RE: EERA Hearing Comments
Coneflower Solar Project
PUC Docket No. IP7132/GS-24-215
OAH Docket No. 71-2500-40396

Minnesota Department of Commerce, Energy Environmental Review and Analysis (EERA) staff offers the following comments on the Coneflower Solar Project (Project) proposed by Coneflower Energy, LLC (Coneflower Solar).

Figure 41. Future Garvin Area Infrastructure

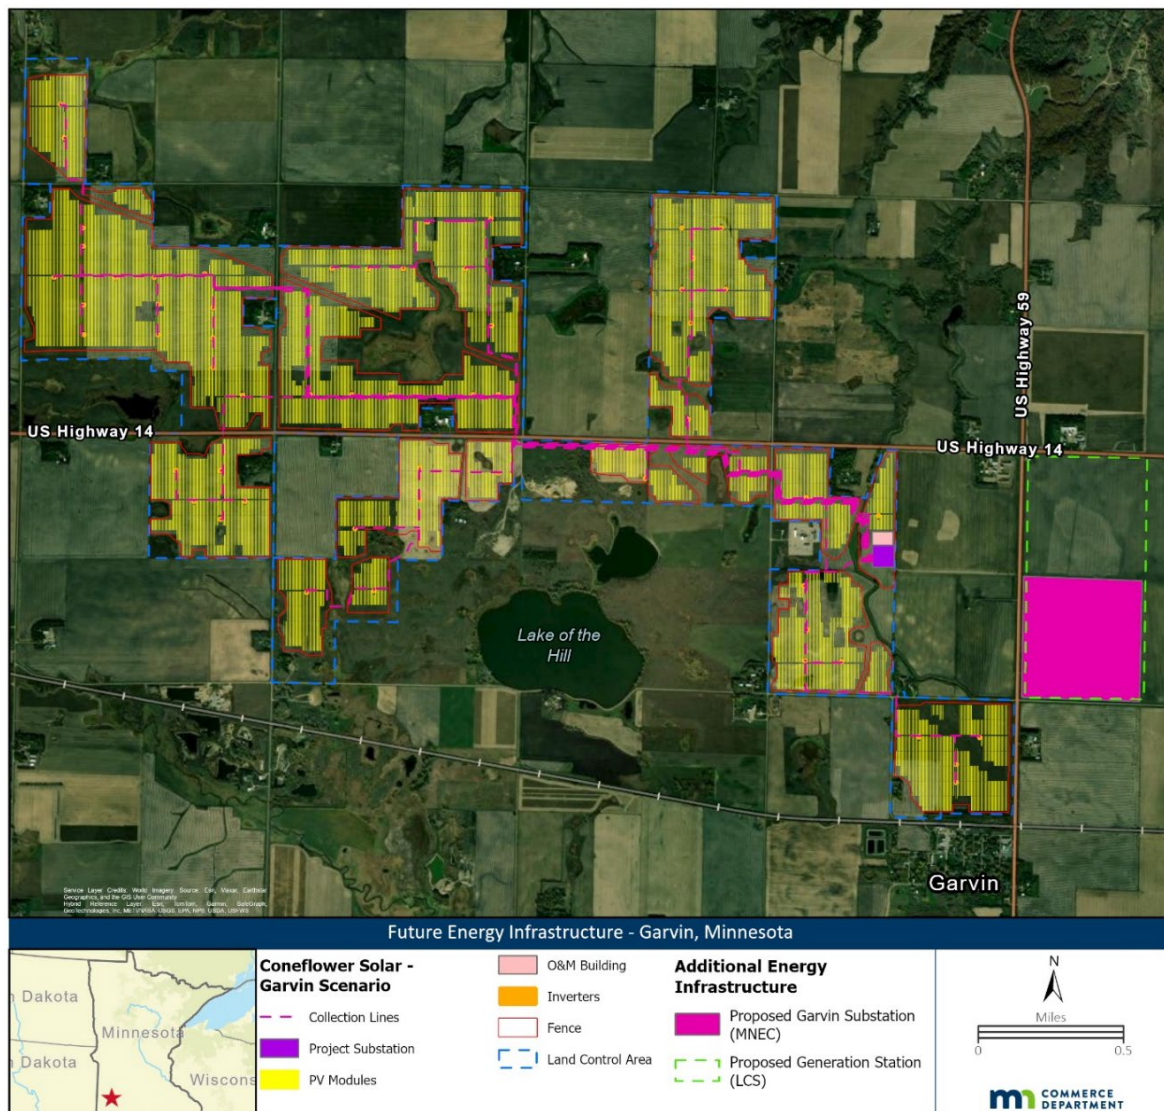
Figure 41 has been corrected to include the following additional future energy infrastructure proposed for the Garvin area in separate proceedings – the Minnesota Energy Connection Project’s Proposed Garvin Substation ([Docket No. E002/TL-22-132](#)) and the Lyon County Station Project’s Proposed Generation Station ([Docket No. E002/CN-23-212](#)).
